**Re: Coalpac Expansion Modifications – Response to Submissions
(DA-200-5-2003 MOD 2 and 07_0127 MOD 4)**

Attachment 1: OEH Review of Biodiversity Impacts

OEH Review of Biodiversity Impacts

Figure 1: Northern part of Invincible Mine showing proximity of mapped geodiversity features and proposed open cut and highwall areas.

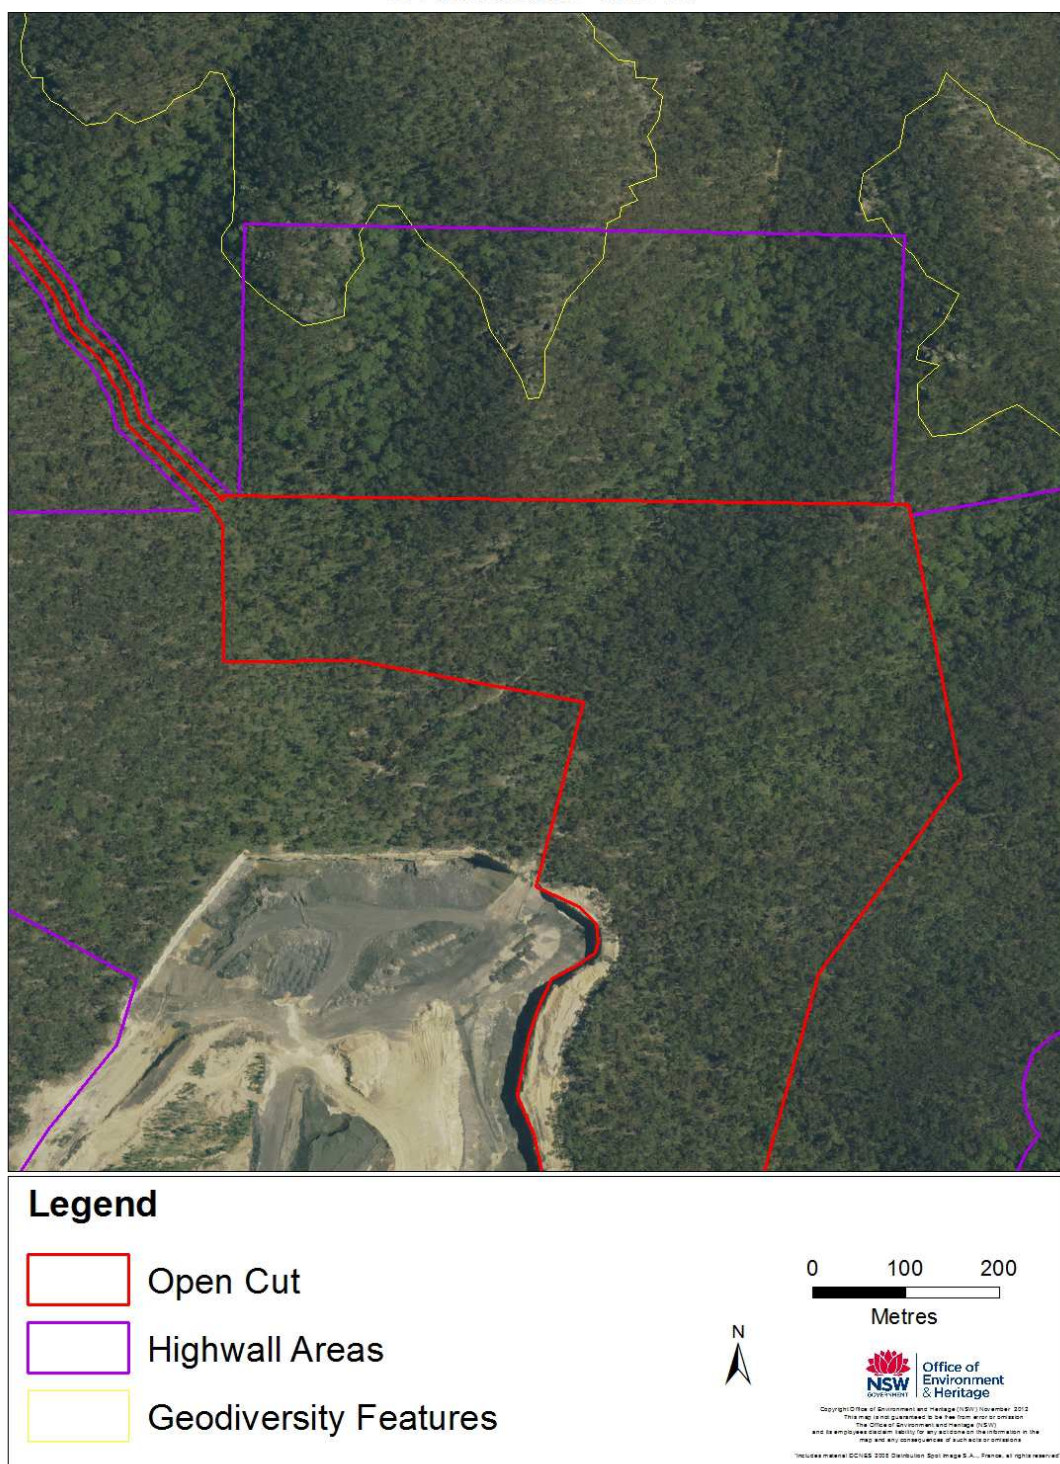
Invincible Colliery: The RTS states that the open cut does not approach within 200 m of any escarpment, however OEHs mapping of geodiversity features shows that these extend to within 110 m of the northern open cut pit (see figure 1).

Invincible Colliery: The RTS states that highwall mining does not “venture under the Escarpments to the east of the Invincible Modifications”. While this statement appears to be true it neglects to mention that this is not the case for the escarpments to the north of the mine as shown in figure 1.

In the submission OEH acknowledged the proposed modifications achieved this 300 m setback in most cases. However, there were some small areas in the northern part of the Invincible modification where the setback was as small as approximately 100 m and much of the open-cut area proposed for the Cullen Valley modification was within 100 m or less of sandstone escarpments (see figures 1 and 2).

- 3.1. OEH recommends that DPE consider the adequacy of the setbacks for the proposal.
- 3.2. OEH recommends that justification be provided for the proposed high wall mining under geodiverse features in the areas to the north of Invincible Mine within the 300 m buffer area (see Figure 1).

Figure 2: Cullen Valley Mine showing proximity of mapped geodiversity features and proposed open cut and highwall areas.

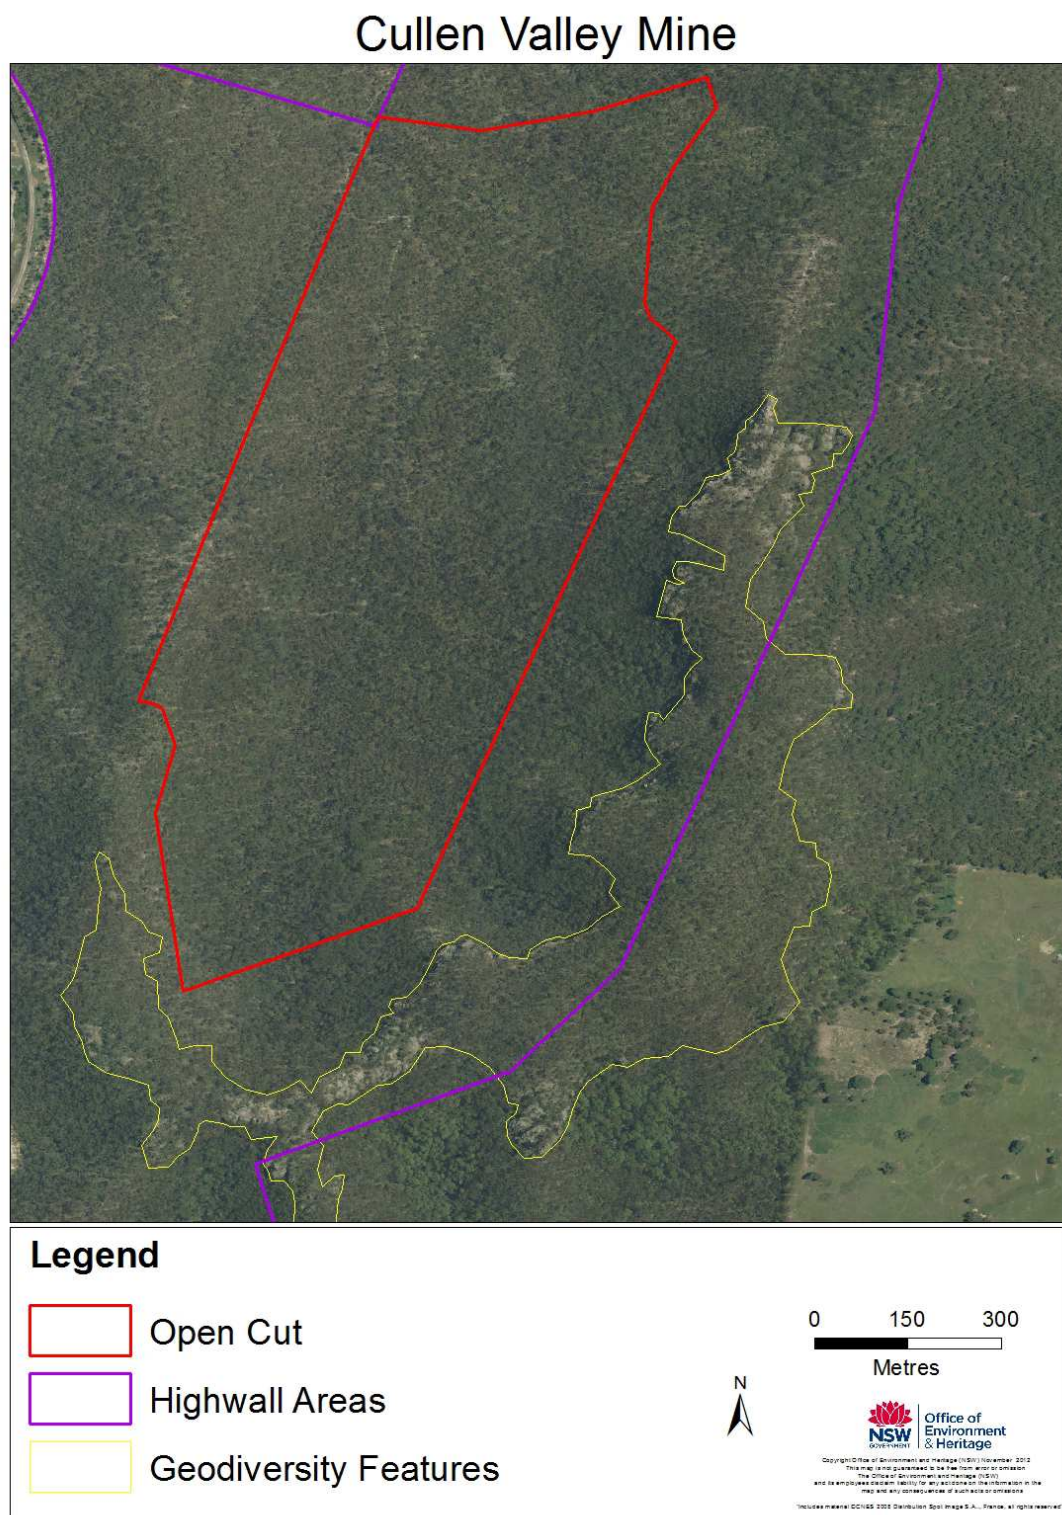
Cullen Valley Colliery: The RTS states that the open cut does encroach within 200 m of the escarpment in parts. Figure 2 shows that these extend to within 100 m of the open cut pit in at least three locations including within approximately 20 m in the southwest.

Cullen Valley Colliery: figure 2 shows that highwall mining will reach up to 200 m beneath the geodiversity features.

The RTS considers the Escarpment at the Cullen Valley Mine as of lesser value and less sensitive because it has an average distance between escarpment and open cut of 177 m. OEH considers this average distance to be meaningless when it can be seen that the actual distance at several points is below 100 m (figure 2).

1. OEH had specifically mentioned “some small areas in the northern part of the Invincible modification where the setback was as small as approximately 100 m” (emphasis added). These areas can be seen in figure 2. This reference to northern part was left out of the RTS. Consequently the distance between the open cut proposal and the geodiversity features remains small and has not been specifically addressed.

Figure 3: Copy of Figure 9 from the RTS.

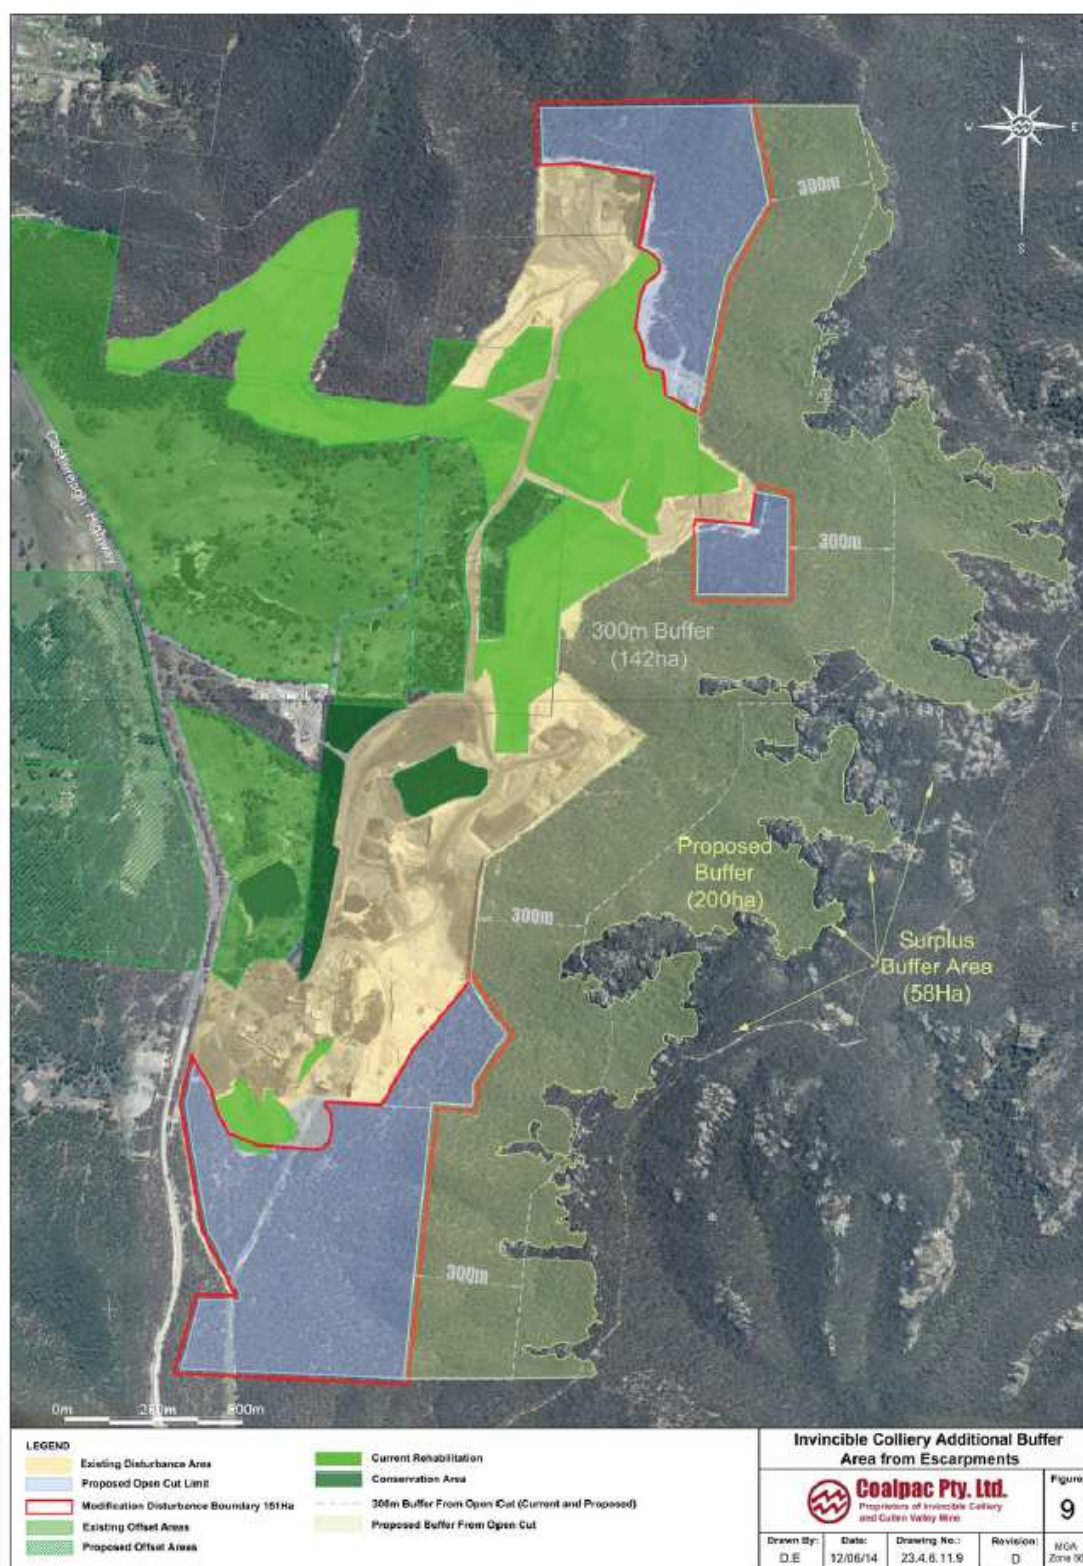
Coalpac responded by mapping a “Proposed Buffer Area” in figure 9 of the RTS. They also considered that the total area of habitat was a, *more appropriate metric for considering buffer zones than any specific linear distance*. They then used this reasoning to calculate that their method gave a 40% greater buffer area than the 300 m buffer recommended by OEH and the PAC.

3. Please note the OEH buffer was measured from the edge of the geodiverse feature, not from the edge of the proposed and existing open-cut pits. Therefore, the two methods are not comparable. Therefore contention that the buffer on the Invincible mine presented in the RTS is 40% larger than that recommended by OEH (and the PAC) is incorrect.
